SUBJECT: NEW VEHICLE DEMONSTRATION / DELIVERY HOLD

Safety Recall 20S50

Certain 2020 Model Year Explorer Vehicles

Second Row Center Seat Belt Buckle Bolt Not Properly Secured to Seat

FIGURE 1

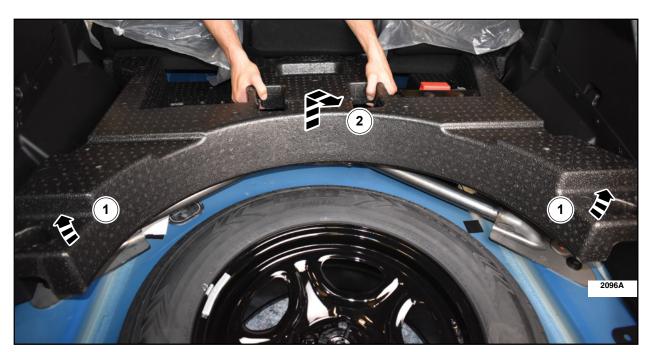
**NOTE:** To aid in the removal and prevention of damage of the loadspace floor rear trim panel, use the lifting locations shown. See Figure 1.

- 1. Using the lifting locations shown, raise the two ends of the loadspace floor rear trim panel.
- 2. Using the lifting locations shown, lift upwards and towards the rear of the vehicle to remove the loadspace floor rear trim panel.

**NOTE:** To aid in the installation and prevention of damage of the loadspace floor rear trim panel, reverse the removal procedure. See Figure 1.
